# Muazuddin Textile Ltd. (Sheds)

16 November 2021

# Observations

## **Lack of lateral stability system**

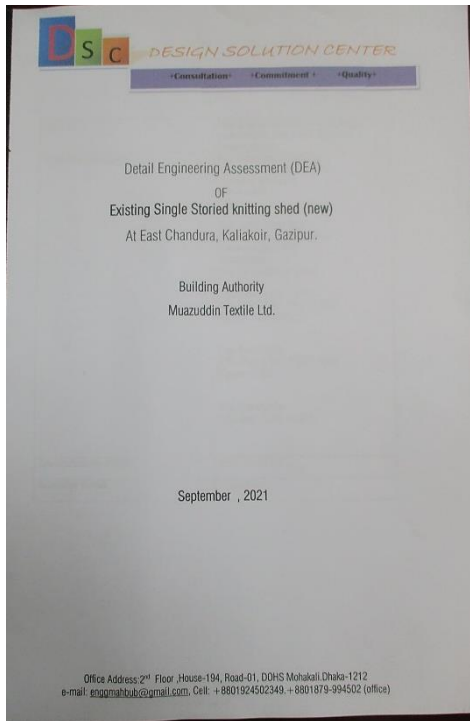
Absence of roof bracing & lateral load transfer media along ridge

Lack of lateral stability system observed at the roof of the shed. Building engineer is required to check the lateral stability of the structure and suggest proper remedial actions accordingly.

DEA report

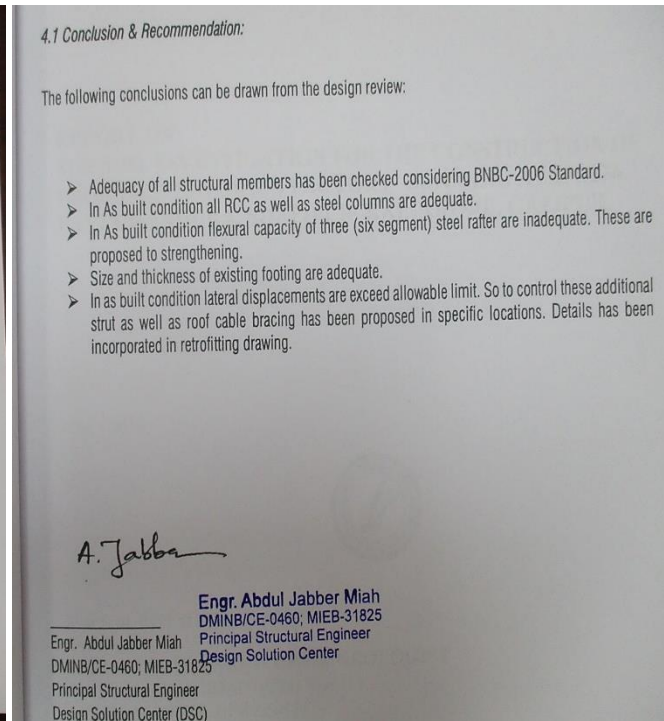
20.7 MPa concrete strength considered in the Detail Engineering Assessment (DEA) without any test report. Seismic design parameter (R) for RC frame not considered in the DEA & uplift check for steel base plate connection not incorporated in the report. Also, there are some discrepancies in the as-built drawings. However, the building engineer is required to revise the DEA report & retrofitting scheme based on as-built drawings, in-situ material strength and current building code.

Concrete strength,  $f'c=3000$  psi (20.7 MPa) in DEA report

$R=6$  considered, where the structure has RC beam-column frame below steel portal roof.

Building code: BNBC 2006
